Appl. No. 10/644,442
Amdt. Dated March 14, 2005
Reply to Office action of September 13, 2004

Amendment to the Drawings:

Annotated Sheet Showing Changes

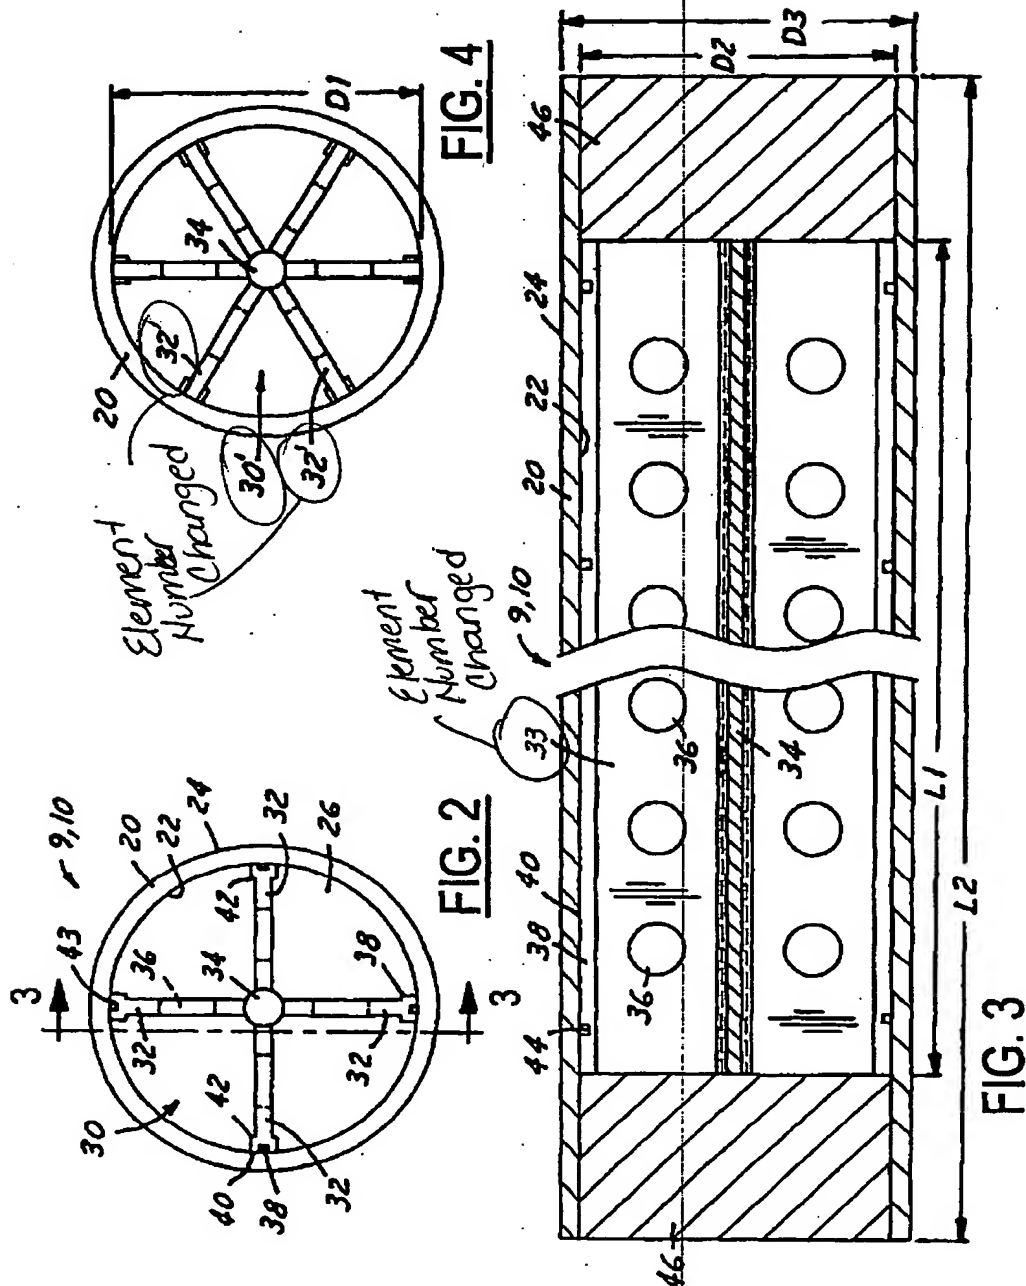
The attached sheet of drawings includes changes to Figures 3 and 4. This sheet, which includes Figures 2, 3 and 4, replaces the original sheet including Figures 2, 3 and 4. In Figure 3, previously designated element 32 has been changed to 33. In Figure 4, previously designated elements 30 and 32 have been changed to 30' and 32', respectively.

The Office action objected to the drawings because reference numerals 30 and 32 were each used to identify a part and then reused to identify a modification of such part. The Applicant has amended Figures 3 and 4 to change element number 32 to 32' and 33, respectively. Also, Figure 3 was amended to change element number 30 to 30'. Further, the specification has been amended, as described below, to change the element numbers as well. Accordingly, the Applicants request that the objection to the drawings be removed.
